Final Channel Design Report
East Fork Jimmy Camp Creek
Creekside at Lorson Ranch Filing No. 1
CDR 192
El Paso County, Colorado

Kiowa Project No. 18020
January 24, 2020

RS = 9000 XSEC-E1.04

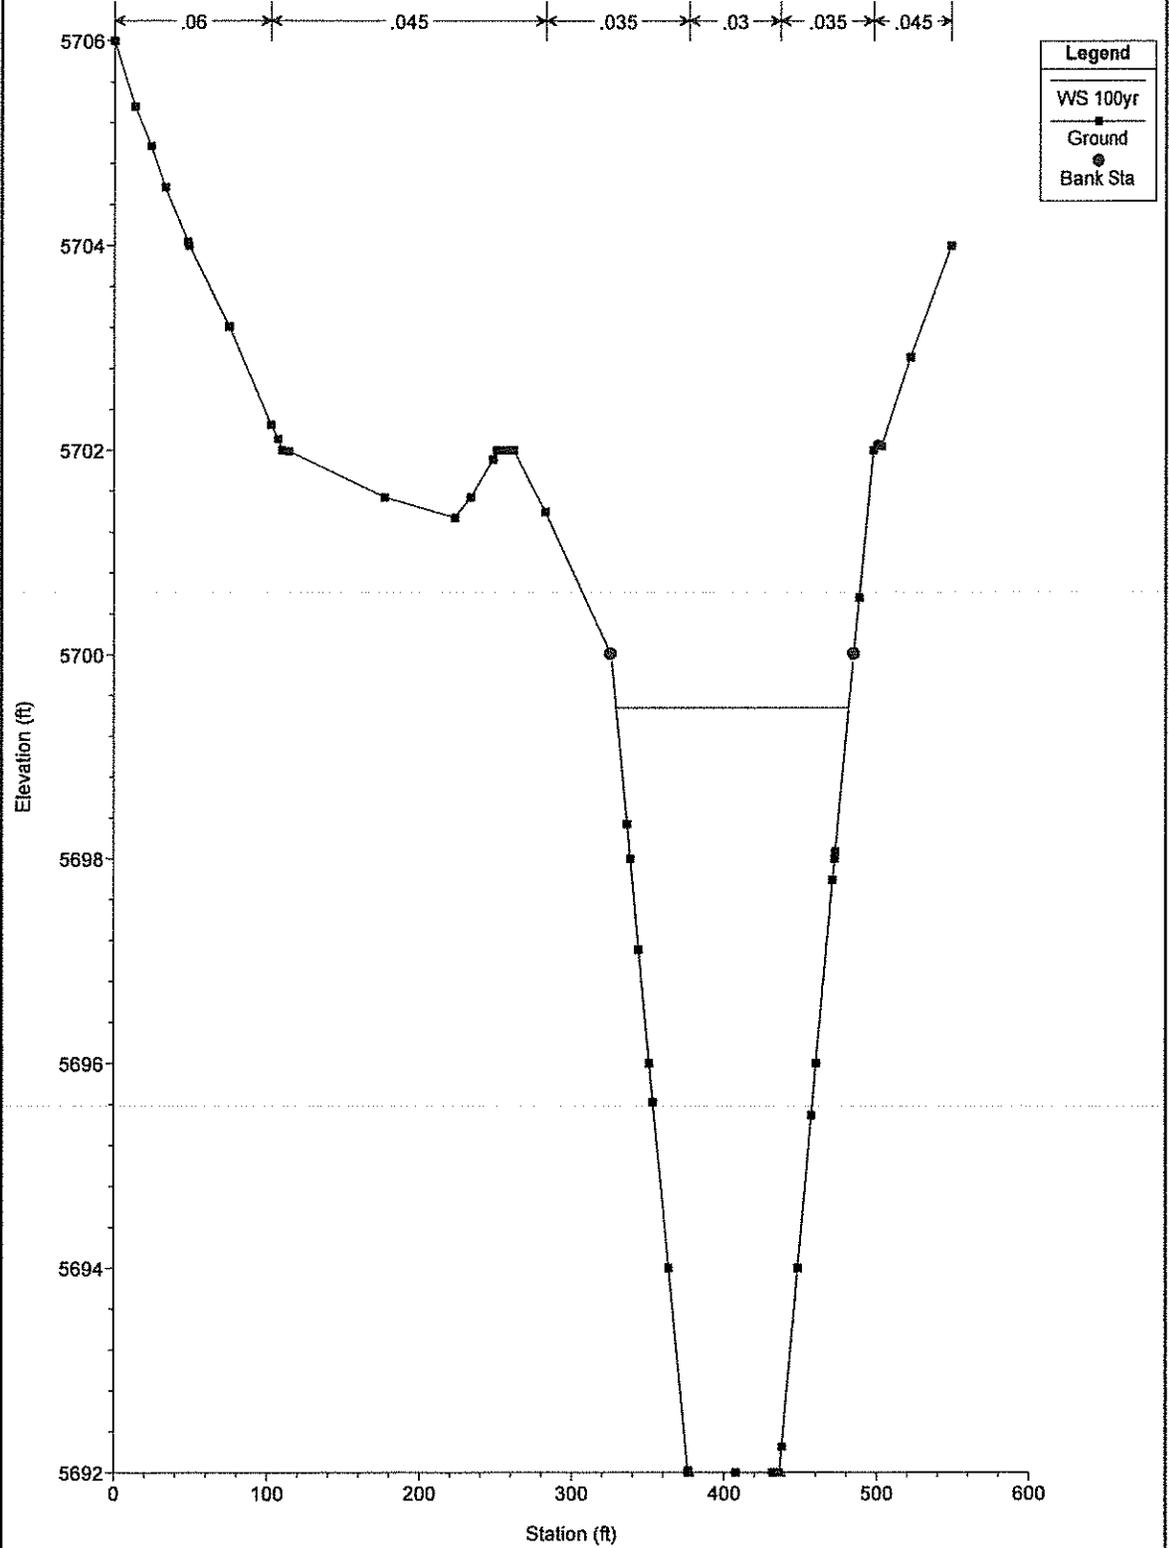
Provide tables for 110 cfs and 550 cfs as well.

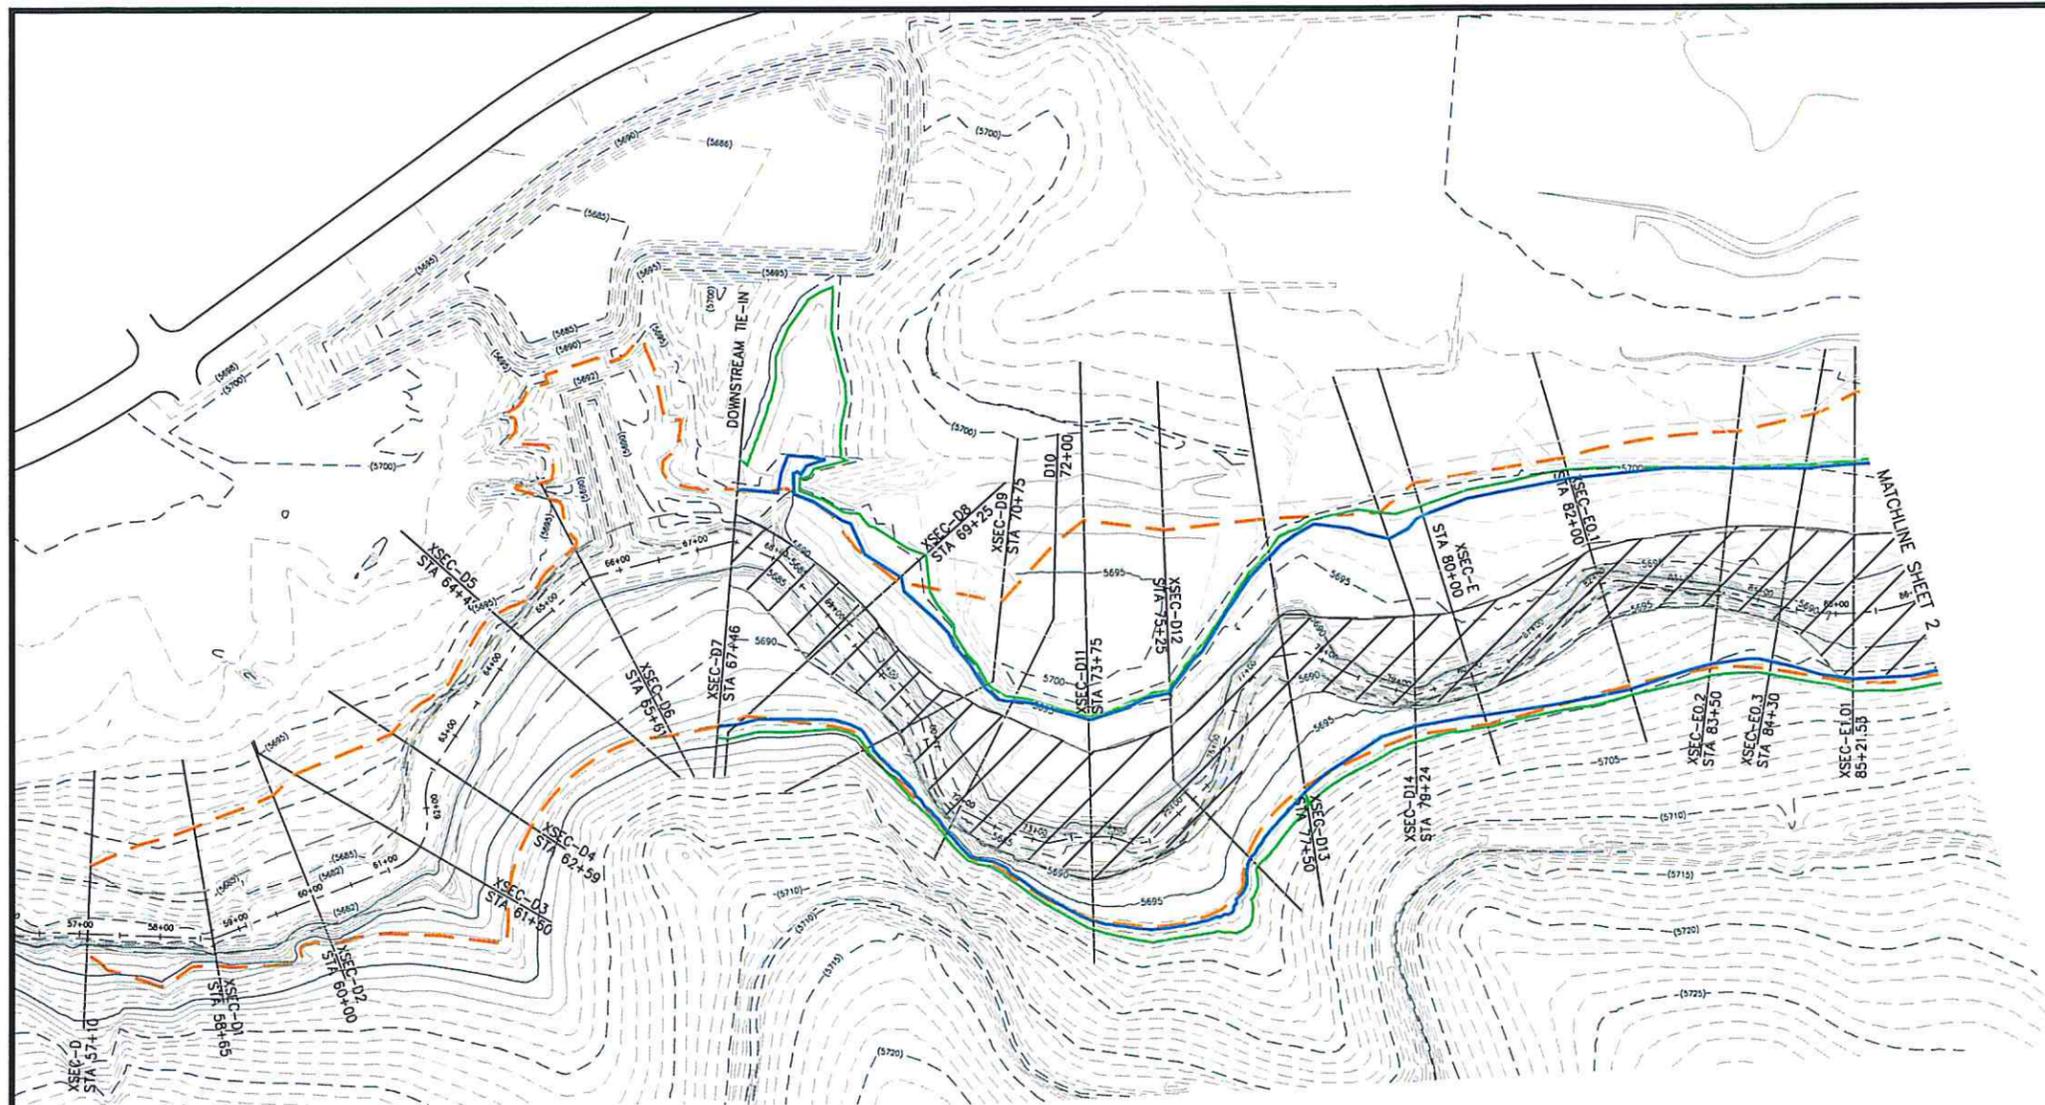
Provide the next sheet to the west or separate plan showing the stationing.
